10
11 IN THE MATTER OF:) **DECLARATION OF BEN ANDERSON**
12 ADMINISTRATIVE CIVIL LIABILITY COMPLAINT) **IN SUPPORT OF SAN ALTOS –**
13 No. R9-2015-0110) **LEMON GROVE, LLC’S LEGAL AND**
AGAINST SAN ALTOS – LEMON GROVE, LLC) **TECHNICAL ARGUMENTS AND**
14) **ANALYSIS IN OPPOSITION TO**
15) **ADMINISTRATIVE CIVIL LIABILITY**
16) **COMPLAINT NO. R9-2015-0110**
17)
18)
19)
20)
21)
22)
23)
24)
25)
26)
27)
28)

Subject: PIN: SM-828060:wchiu

This letter will serve as San Altos-Lemon Grove, LLC's ("LLC") response to the Notice of Violation No. R9-2014-0153 issued by the San Diego Water Board on December 19, 2014. The LLC takes its responsibilities under Order No. 2009-0009-DWR seriously and has made a determined effort to correct any deficiencies at the construction site and employ the most effective Best Management Practices available. We have employed three different contractors with over 1,400 man hours including Saturdays and Sundays, associated BMP equipment and material and management for the project. To date the costs exceed \$ 60,000 in an effort to remedy deficiencies on the site since the rain events in early December. While we understand that money spent is not a measure of eff

1: Failure to Comply with Discharge Prohibitions for Construction Activities

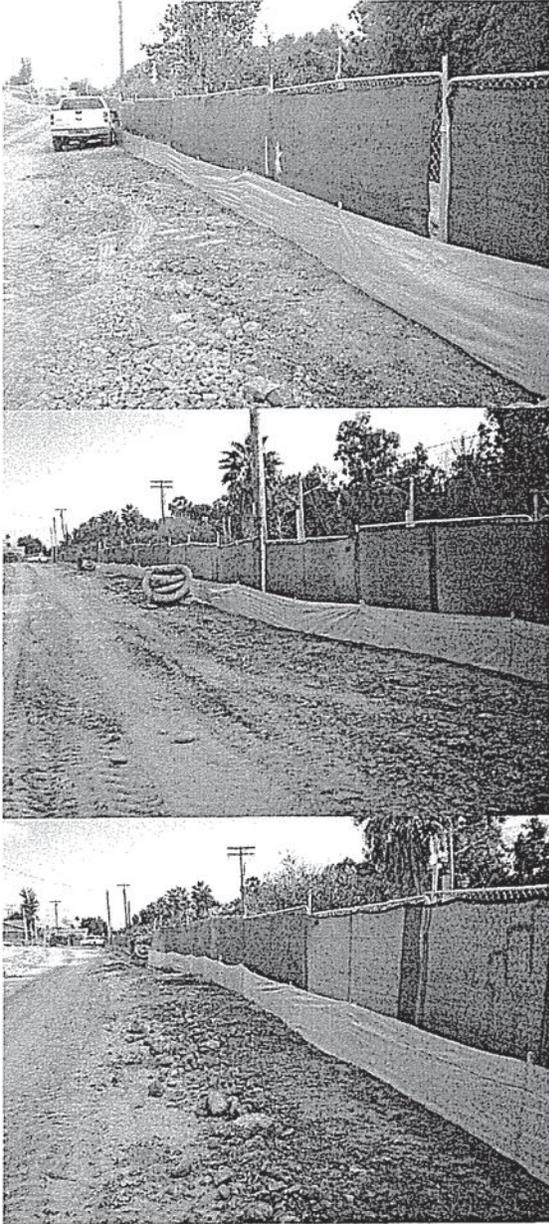
Observation: On December 4, 2014, the San Diego Water Board inspected the Valencia construction site (WDID 937C369143). San Altos Lemon Grove LLC is the Legally Responsible Person (LRP) enrolled under the Construction General Permit (CGP) for the site. On December 4 and 11, 2014, the City of Lemon Grove documented unauthorized discharges of sediment and sediment-laden storm water from the site due to inadequate implementation of best management practices (BMPs). On December 15, 2014, the San Diego Water Board inspector observed evidence of sediment discharged from the site due to inadequate and ineffective implementation of BMPs, constituting an unauthorized discharge of sediment from the site. See attached December 15, 2014 Facility Inspection Report Photos 9 through 12 and Attachments.

- c. Observation:** During the December 15, 2014 inspection, the San Diego Water Board inspector observed the lack of effective erosion controls, perimeter sediment controls, and run-on and runoff controls required by the CGP, which directly lead to erosion and sedimentation that ultimately resulted in the discharge of sediment from the site observed on December 15, 2014. The discharge was a result of the implementation of controls, structures, and BMPs that do not achieve BCT. See attached December 4, 2014 Facility Inspection Report Photos 1 through 14.

b. **Observation:** During the December 15, 2014 inspection, the San Diego Water Board inspector observed several areas of the site where perimeter controls were

not established or maintained to sufficiently control erosion and sediment discharges from the site. See attached December 15, 2014 Facility Inspection Report Photos 9 through 14.

Response: We repaired and supplemented the perimeter silt fence and gravel bags on the southern and eastern perimeters. Additionally, we have

implemented additional gravel bags crossing graded streets at the project entries providing additional containment. Lastly, we have stockpiled straw wadde and gravel bags at the entries for pre rain staging.

Response: See response to No. 1. Erosion control measures have been enhanced by additional berming and gravel bagging in all streets prior to rain events. Run-on and runoff controls are addressed with the response to violation No. 9.

Response: See responses to No. 1 and No. 9.

These photos show the implementation of perimeter sediment controls and run-on/runoff controls to prevent discharges of sediment from the site.

4: BMP's for Vehicle Storage and Maintenance

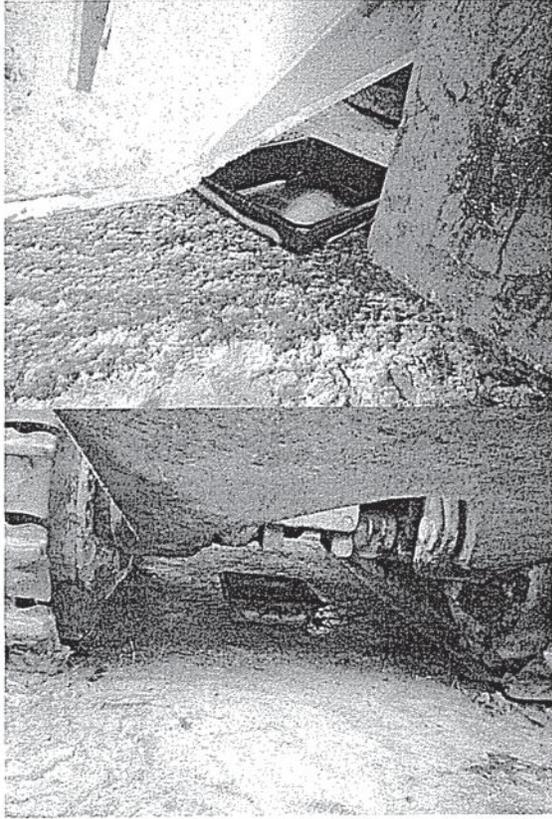
- a. **Pursuant to Provision X and Section B.3.a of Attachment D of State Water Board Order No. 2009-0009-DWQ:** Risk Level 2 dischargers are required to prevent oil, grease, or fuel to leak in to the ground, storm drains or surface waters.
- b. **Pursuant to Provision X and Section B.3.b of Attachment D of State Water Board Order No. 2009-0009-DWQ:** Risk Level 2 dischargers are required to place all equipment or vehicles, which are to be fueled, maintained and stored in a designated area fitted with appropriate BMPs.
- c. **Observation:** During the December 15, 2014 inspection, the San Diego Water Board inspector observed several construction vehicles stored without appropriate BMPs to prevent oil, grease or fuel to leak in to the ground, storm drains or surface waters. See attached December 4, 2014 Facility Inspection Report Photos 2 and 3.

Response: Owner met with all contractors immediately after December 15, 2014 on site meeting. Contractors were notified that under no circumstances that equipment may be parked drain pans. Contractors are now required to park in identified specific areas provided by project management. Project management providing daily inspection regarding drain pans.

Photos with vehicles stored with appropriate BMP's
